Cheetwood House

21 Newton Street
Manchester
M1 1FZ

architecture:m

Responses are marked in RED.

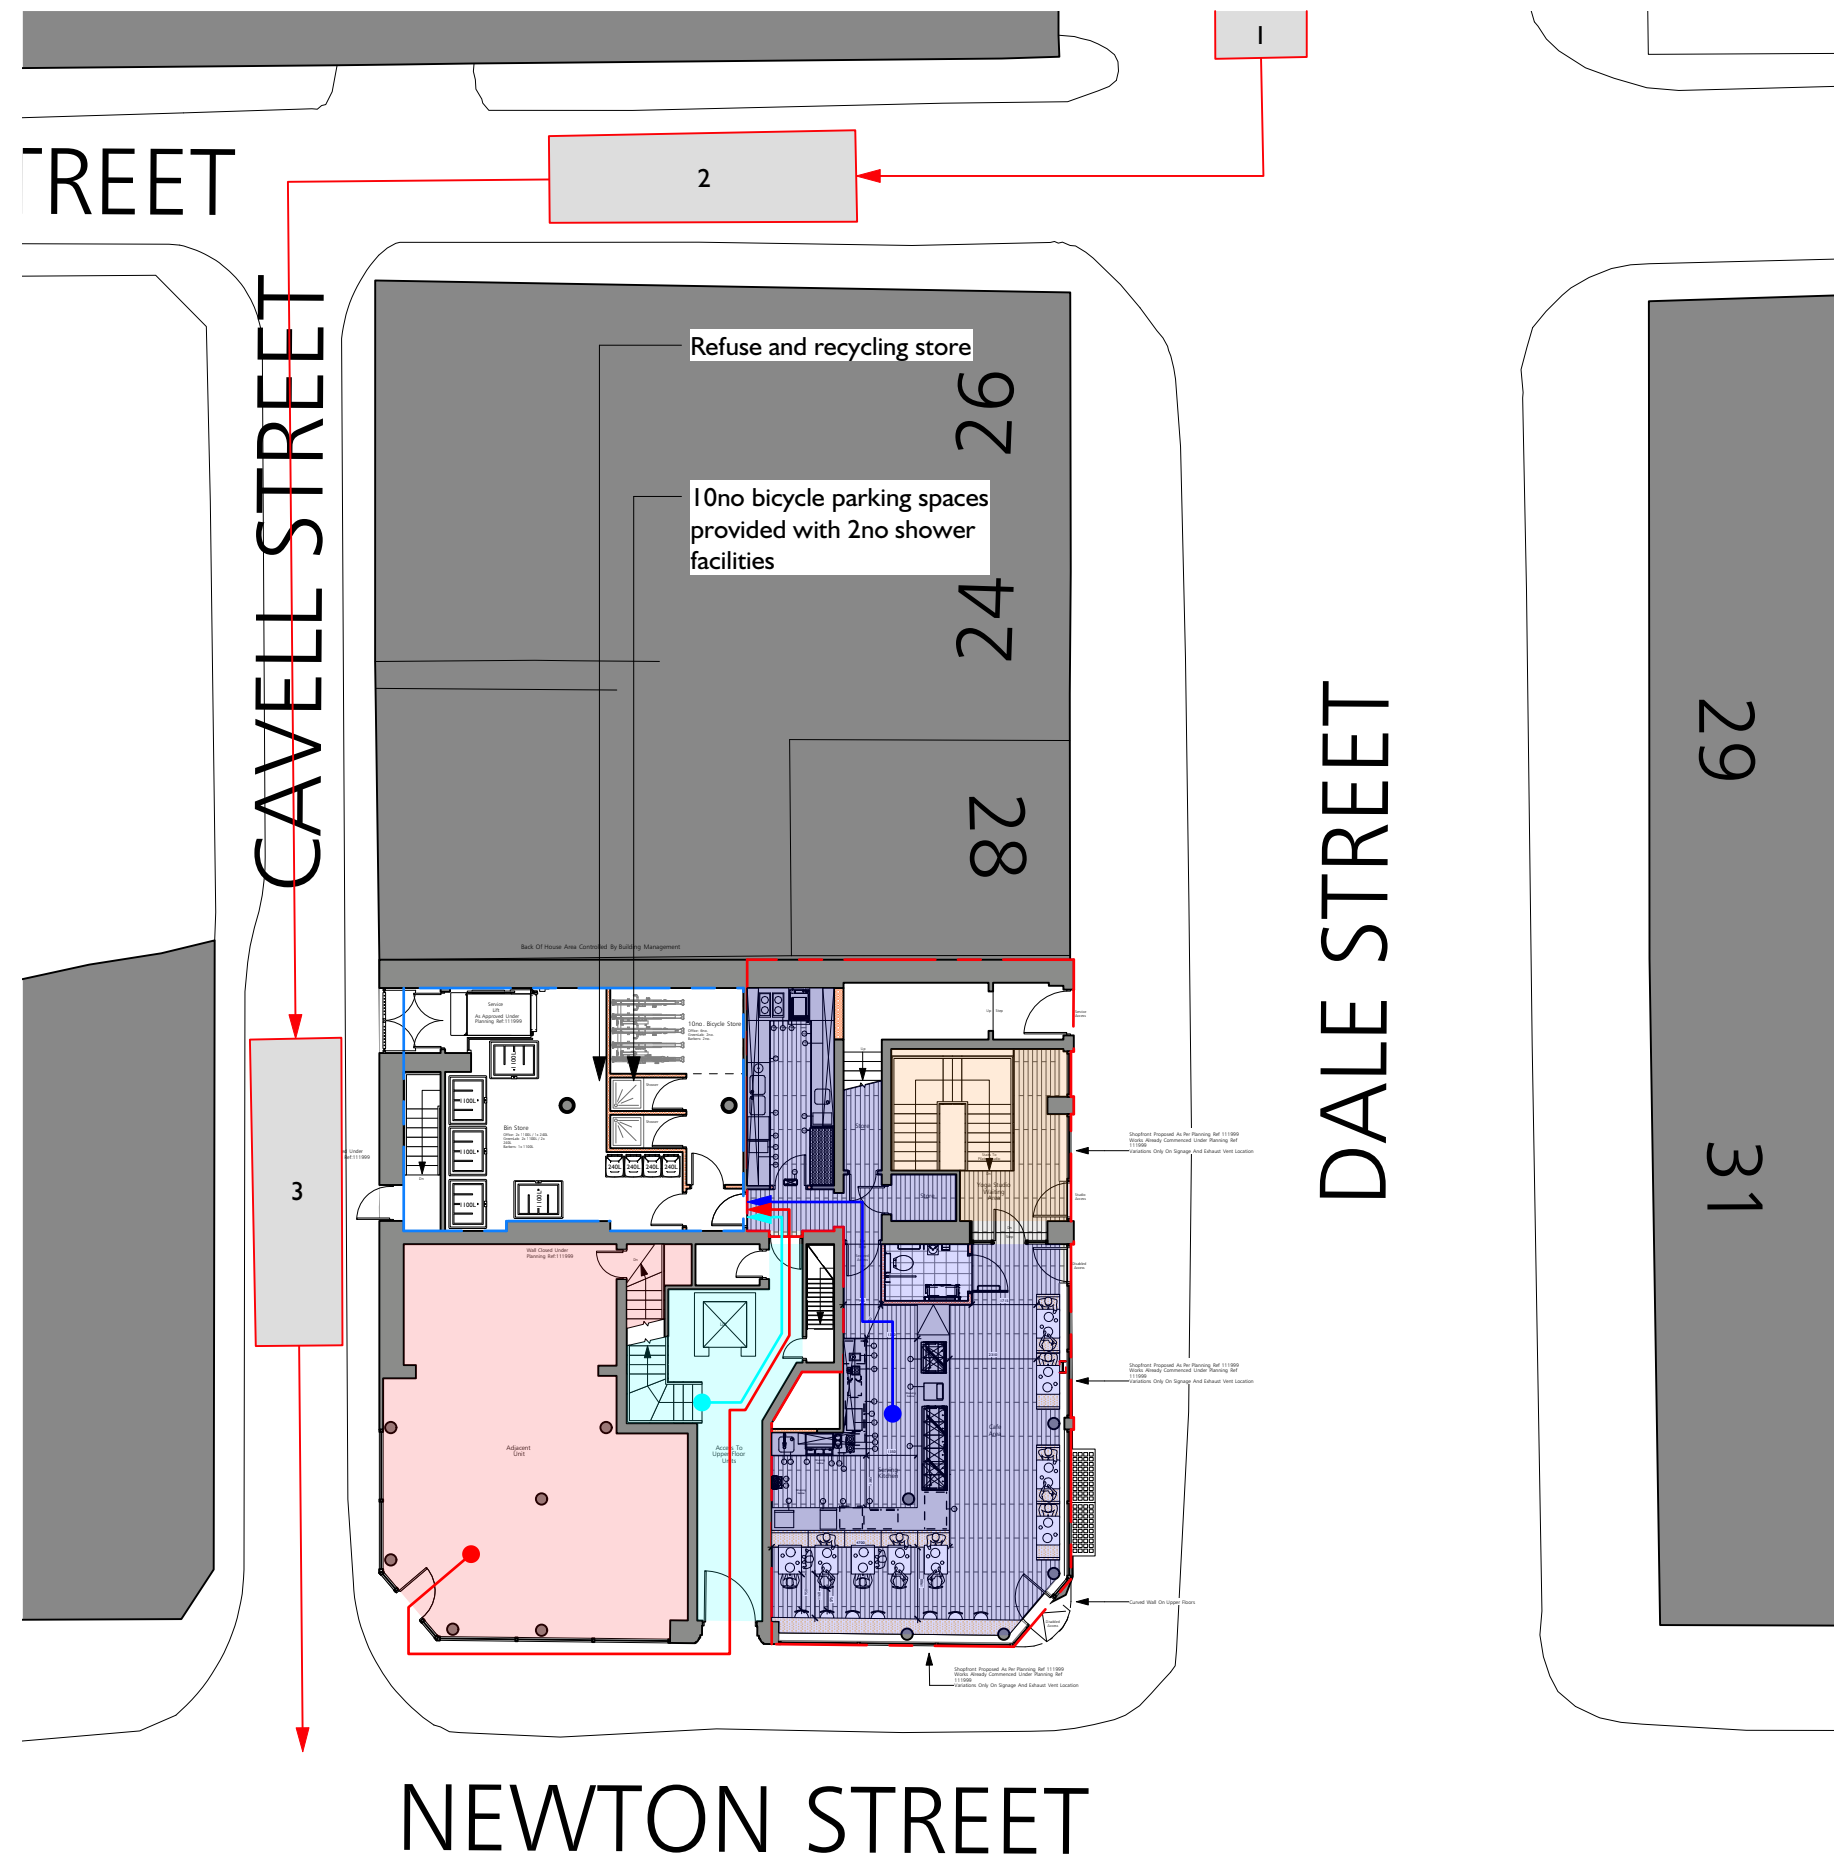
5. Servicing shall take place from Back Piccadilly in accordance with a servicing strategy that has been submitted to and agreed in writing by the City Council as local planning authority before the development commences.

Servicing will take place to the rear of Cheetwood House. Vans/waste refuse units will turn right off one-way traffic on Dale Street, onto Little Lever Street whereby Cavell Street can be accessed.

The waste/recycling storage is accessed from the rear of Cheetwood House from Cavell Street, which will provide ease of access for refuse collection.

Daily pick up will be provided by an external waste management company. Once the collection truck has arrived, containers will be wheeled out from the loading bay onto Cavell Street through access controlled gates.

Proposed Basement Plan

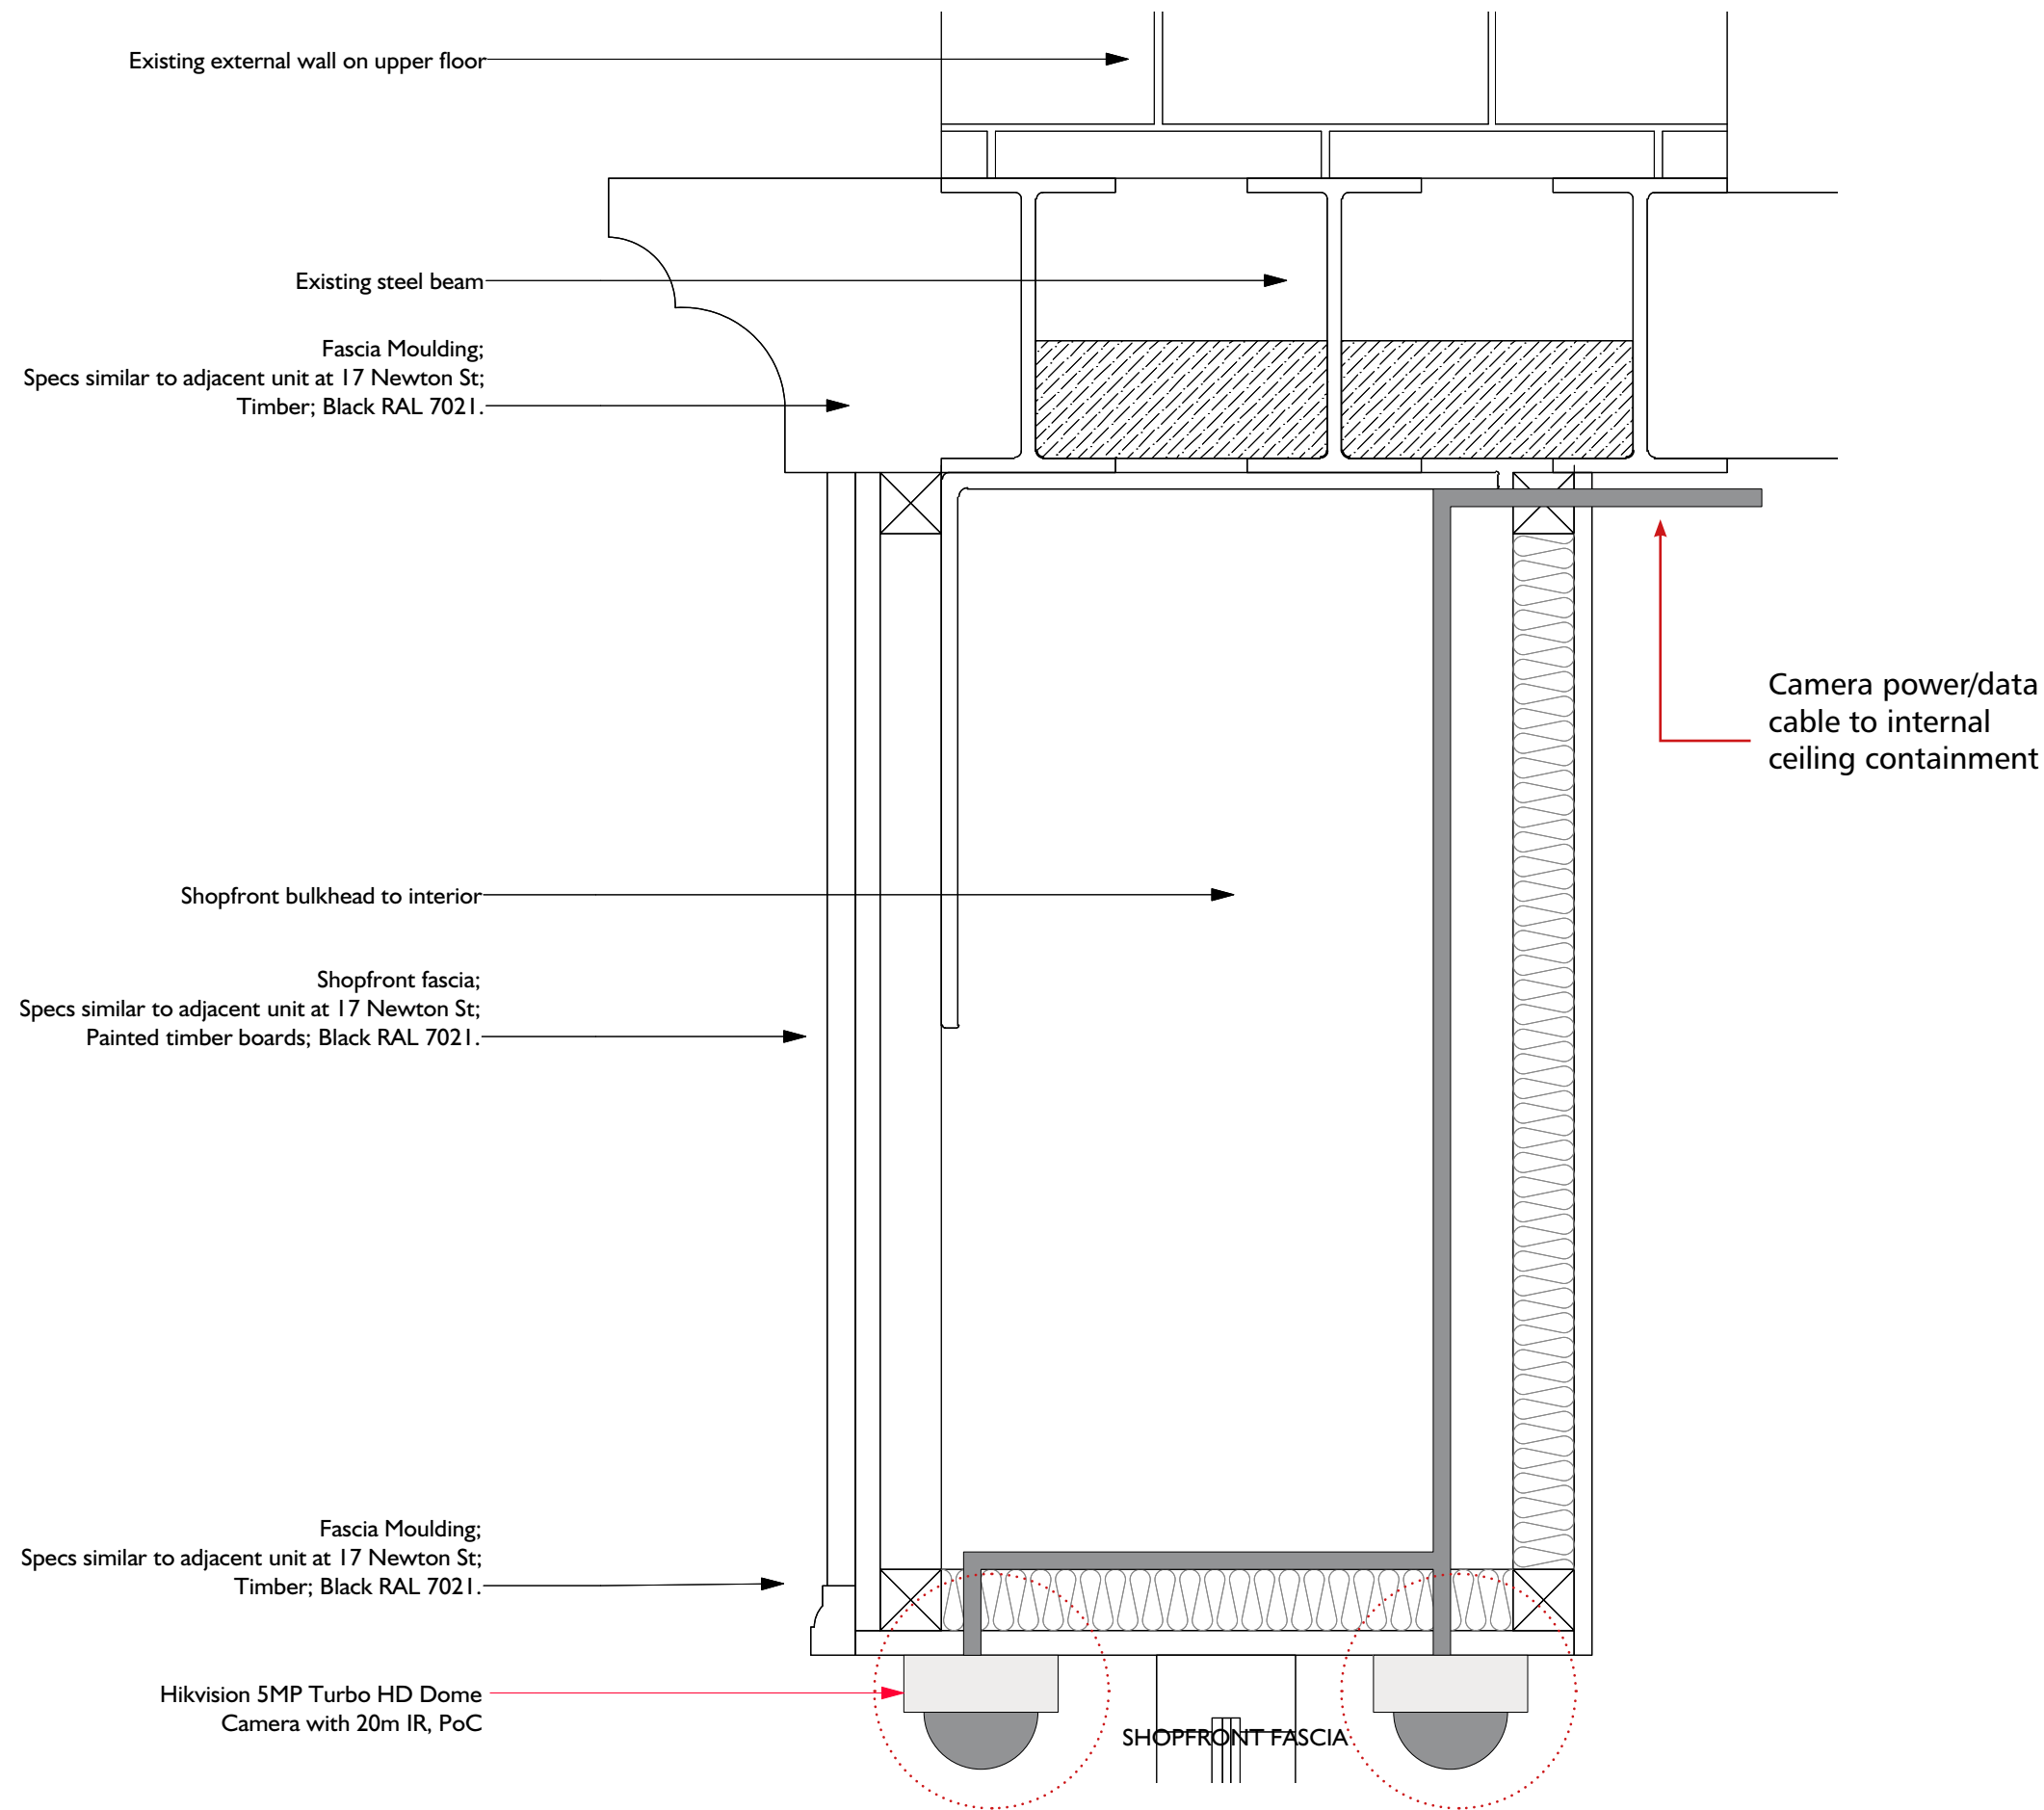
10. The development hereby approved shall not be occupied or used unless and until the security measures set out in the Crime Impact Assessment (Sean Bastow’s email to Matthew@ArchitectureM dated 15 October 2019) received by the City Council as local planning authority on 20 January 2020, have been implemented in full.

- A CCTV system should be included within these premises and should be capable of monitoring the following areas: external doorways, and all internal spaces.

- An intruder alarm should be installed or if there is an existing one within the current building for the coverage of this to be reviewed and extended to cover the proposed second floor when not in use.

- Hikvision 5MP Turbo HD Dome Camera with 20m IR, PoC camera is proposed with specification/ appearance below.
- Signage should be displayed to indicate the areas of the premises that are restricted to staff only.

- Blue circles indicate the location of signage to restricted staff only areas. Image below is an example of the brushed aluminium finish to be used and installed on new, non-original doors.

- Any staff areas that are to be included within the proposal should be access controlled and restricted to members of staff only.
 - In addition to the point above, the orange area on the plan is accessible only by staff of the GreenLab with the red area being accessible by all staff of Cheetwood House. Access locks will be installed on the non-original doors leading to the green & red areas, where Staff Only signs are installed.

- Proposed CCTV Camera
- Proposed Cabling Route
- Proposed Door Signage
